June 16, 2020
Revised July 14, 2020

Knox-Goodrich Building
34-36 S. First Street
San Jose, California

PRESERVATION PLAN

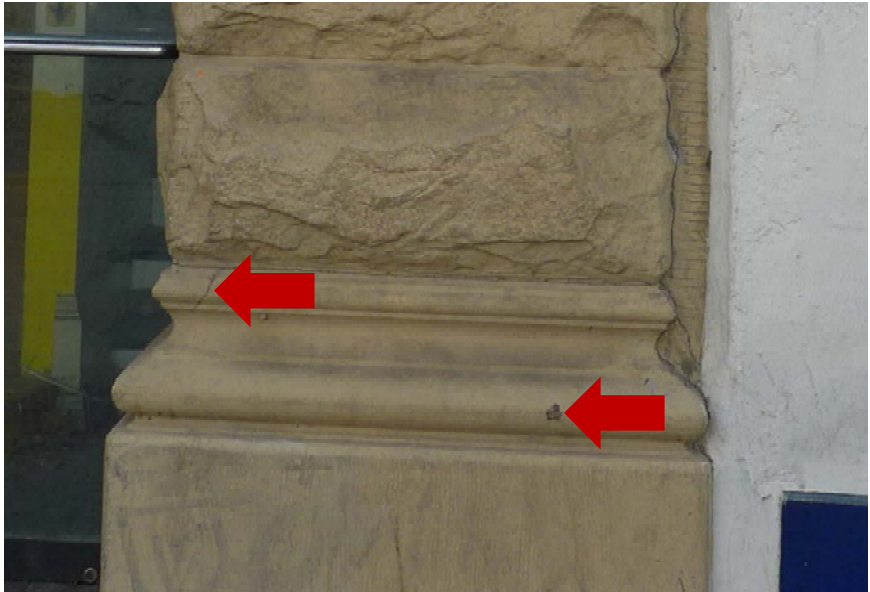
6. Cracks at the decorative band and ornamental end element (red arrows). Open joints are visible at the underside of the decorative band (blue arrow). Between the cracking and separation at the joint this end stone should be reviewed to ensure it is sound and that no pieces will spall off onto the sidewalk below.

Refer to N.P.S. *Technical Preservation Services, Brief 47* "Maintaining the Exterior of Small and Medium Size Historic Buildings."

Review planned crack and spall repairs with historic architect.

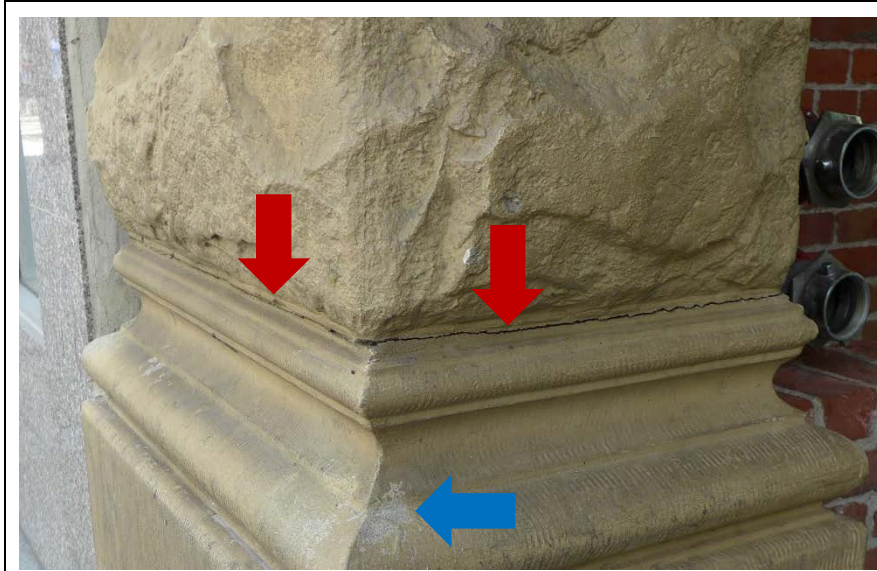
<p>8. Joint between the first-floor replacement stone and the adjacent building is open.</p> <p>Seal joint and paint to match surrounding surface.</p> <p>Review planned repair with historic architect prior to undertaking work.</p>
	<p>9. Chip at lower base (front façade, east side) and hairline crack at corner of the base.</p> <p>Review repair with historic architect prior to undertaking work.</p>

10. Crack between the faux stone elements at the base (red arrow).

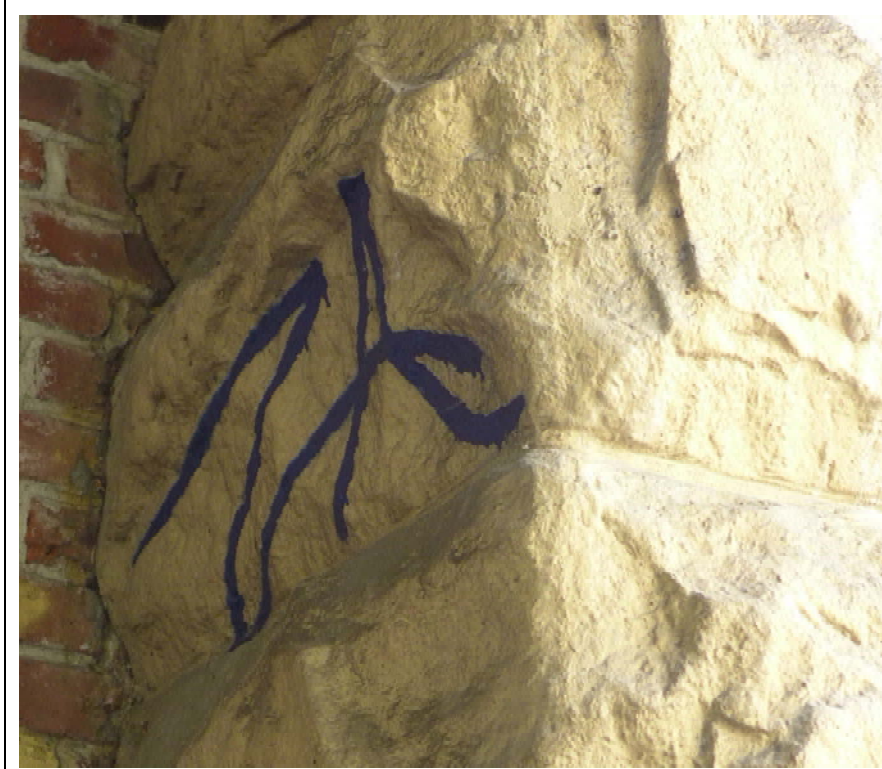
Coating on the corner is damaged (blue arrow).
Recoat the faux stone at the first floor of the structure.

Fill open joint and painted.

Review repair with historic architect prior to undertaking work.
